## BOSTON EDISON COMPANY

## PILGRIM NUCLEAR POWER STATION

### AMENDMENT TO FACILITY OPERATING LICENSE

Amendment No. 78 License No. DPR-35

## TABLE 3.11-1 OPERATING LIMIT MCPR VALUES

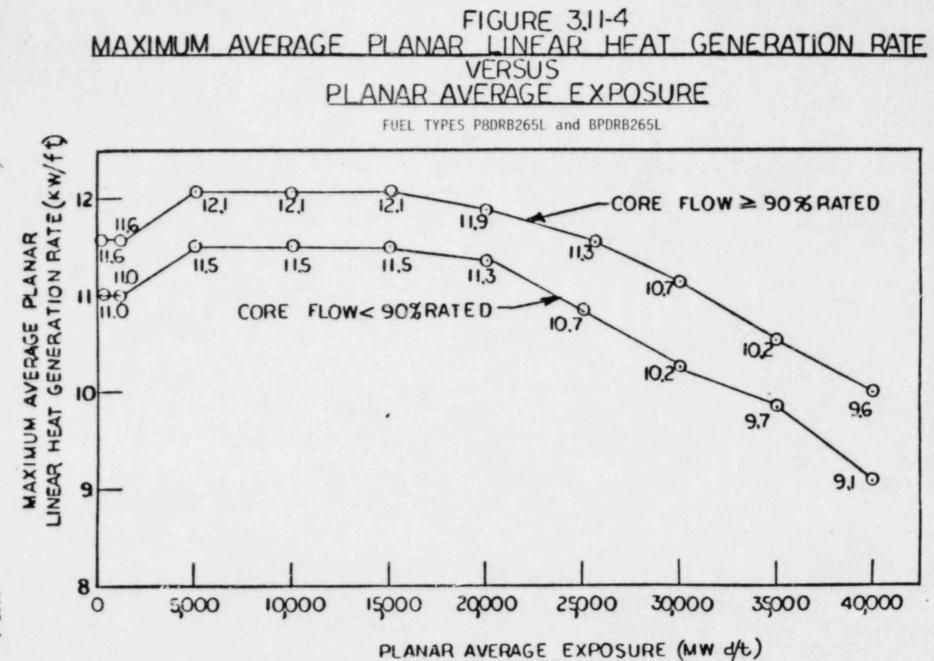
A. MCPR Operating Limit from Beginning of Cycle (BOC) to BOC + 6000 MWD/T.

8 x 8	P8 x 8R/BP8x8R
For all values of $\boldsymbol{\tau}$	1.36	1.40

B. MCPR Operating Limit from BOC + 6000 MWD/T to End of Cycle.

τ	<u>8 x 8</u>	P8x8R/BP8x8R
τ <u>&lt;</u> 0	1.38	1.40
0.0 < τ <u>&lt;</u> 0.1	1.39	1.41
0 <b>.</b> 1 < τ ≤ 0 <b>.</b> 2	1.39	1.41
0.2 < τ <u>&lt;</u> 0.3	1.40	1.42
0.3 < τ <u>&lt;</u> 0.4	1.40	1.42
0.4 < T < 0.5	1.41	1.43
0.5 < τ <u>&lt;</u> 0.6	1.41	1.43
0.6 < T < 0.7	1.42	1.44
0.7 < T < 0.8	1.42	1.44
0.8 < τ <u>&lt;</u> 0.9	1.43	1.45 .
0.9 < T < 1.0	1.43	1.45

205E-4

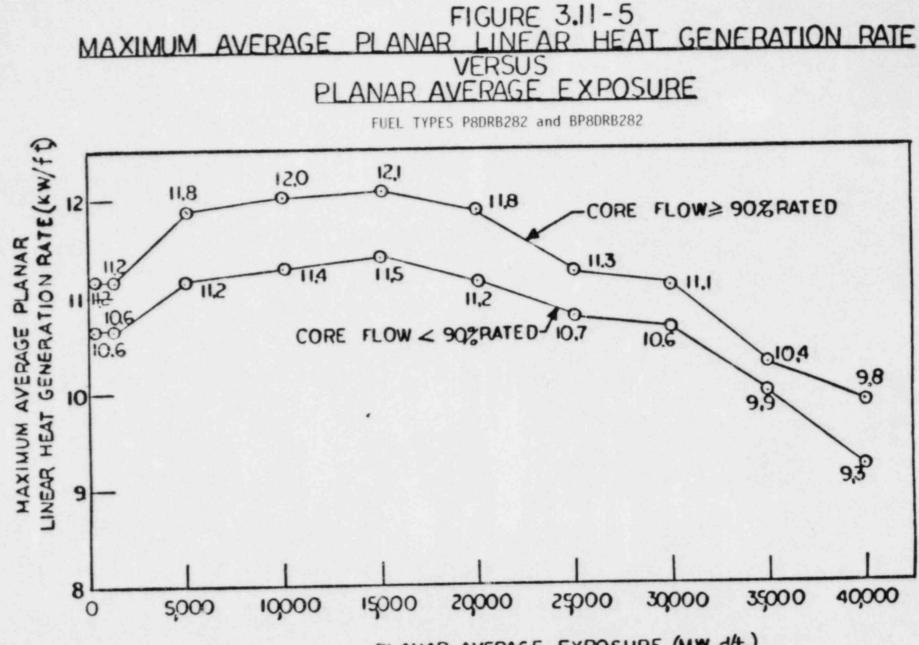
PLANAR AVERAGE EXPOSURE (MW 4/2)
